STAFF REPORT: SEPTEMBER 11, 2024, REGULAR MEETING PREPARED BY: T. BOSCARINO

**APPLICATION NUMBER:** HDC2024-00440

**ADDRESS: 311 WATSON**

**SCOPE**: ERECT CARRIAGE HOUSE

Site plan depicting proposed development. Image from application materials.

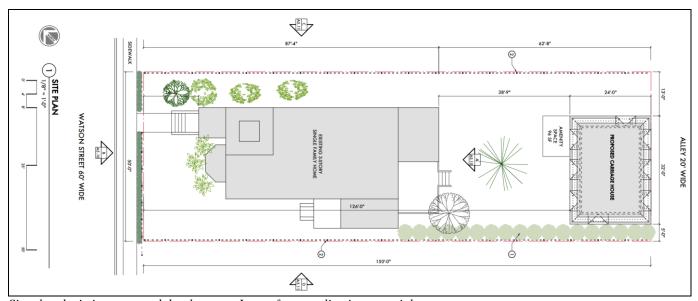
- The overall site plan and location of the proposed building, at the rear of the yard and opening to the alley, is consistent with the character of the district and supported by the "relationship of significant landscape features and surface treatments" and "relationship of lot coverage" elements quoted above.
- The form, massing, and detail, especially the Mansard roof, wood trim, and dormers lie within the "invention within a style" preservation approach and are compatible with the property and its setting, in staff opinion. The copper cladding of the dormers, which employs a historic material in a non-historic manner, along with the rectangular slates depicted in construction drawings, provide the differentiation required by Standard #9 of the Secretary of the Interior's Standards for Rehabilitation.<sup>2</sup>

Elevations of proposed new building. Image from application materials.

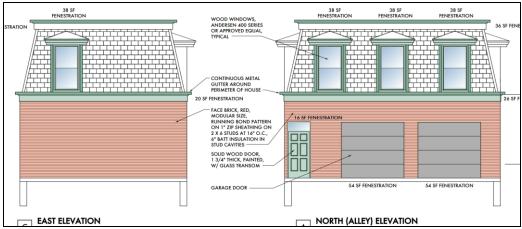
• The first floor of the proposed building displays a clear lack of texture and depth. This is incongruous with respect to the more elaborate Mansard design of the attic story and in contrast to the highly detailed and

textured house at 311 Watson and the other buildings of the district as a whole. The two floors appear to be stylistically and conceptually disconnected.

- The first floor of the proposed building is also contrary to several Elements of Design: it lacks the expected contrast between brick cladding and stone or wood trim described in "relationship of textures," the "elaborate detail" and "treated" areas described in "relationship of architectural detail," and the "large" and "scaled" elements that "divide facades," as described in "scale of facades and façade elements." The lack of such features emphasizes the horizontal nature of the stretcher-bond brick, contrary to "proportion of building's front façade," which specifically notes "horizontal proportions" as "incompatible."

- Staff suggests that a variety of potential façade treatments could add an appropriate level of texture and detail to the first-floor façade. These may include the use of common-bond brick (matching that of the primary house) rather than stretcher bond, the use of visible stone headers above garage doors, the use of additional first-floor fenestration, or the addition of a projecting feature (this would necessarily have to be on the north, or inward-facing, elevation), such as a porch.

Additional texture, depth, and detail be incorporated into the design for the first floor, to achieve alignment
with the district's Elements of Design, and present a more cohesive overall expression for the new building
(modifications to the second floor may also help to achieve the same purpose). Such modifications are
subject to staff approval.
